**MINERALS PROGRAM INSPECTION REPORT**  
**PHONE: (303) 866-3567**

<b>MINE NAME:</b> Cresson Project	<b>MINE/PROSPECTING ID#:</b> M-1980-244	<b>MINERAL:</b> Gold	<b>COUNTY:</b> Teller
<b>INSPECTION TYPE:</b> Monitoring	<b>INSPECTOR(S):</b> Timothy A. Cazier	<b>INSP. DATE:</b> January 19, 2017	<b>INSP. TIME:</b> 10:30
<b>OPERATOR:</b> Cripple Creek & Victor Gold Mining Company	<b>OPERATOR REPRESENTATIVE:</b> Jeff Campbell	<b>TYPE OF OPERATION:</b> 112d-3 - Designated Mining Operation	
<b>REASON FOR INSPECTION:</b> Normal I&E Program	<b>BOND CALCULATION TYPE:</b> None	<b>BOND AMOUNT:</b> \$173,934,420.00	
<b>DATE OF COMPLAINT:</b> NA	<b>POST INSP. CONTACTS:</b> None	<b>JOINT INSP. AGENCY:</b> None	
<b>WEATHER:</b> Clear	<b>INSPECTOR'S SIGNATURE:</b> 	<b>SIGNATURE DATE:</b> April 3, 2017

Photo 3. Water level in the HGM southwest stormwater sump.

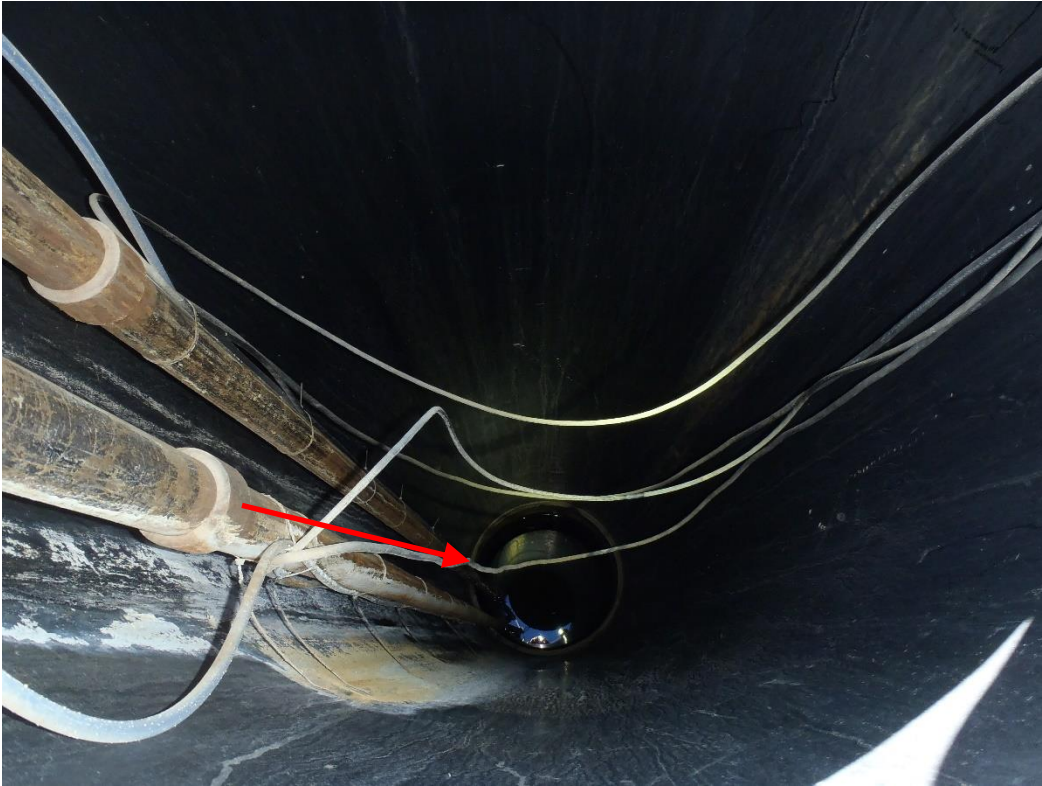
**High Grade Mill:** The Division was accompanied by Gary Horton and Don Rodabough to the HGM to perform an exterior walk-around inspection. The Division noted snow and ice in the leach tank secondary containment area (**Photo 1**). CC&V submitted photographic evidence of removing the snow and ice via email on February 2, 2017, so this was not cited as a problem in this inspection report. The Division also noted a leaking pump on the south side of the neutral pH process water tank (see **Photo 2**). Mr. Rodabough indicated maintenance was scheduled for the pump and the sludge would be cleaned out of the secondary containment as part of the maintenance program. The water level in the southwest stormwater sump (see **Photo 3**) appeared to be well below the overflow elevation of the mill liner. Mr. Rodabough pointed out CC&V had replaced an exterior pipe (see **Photo 4**) from the neutral pH filter press to the process ore thickener with a new rubber lined pipe to prevent leaking the pipe.
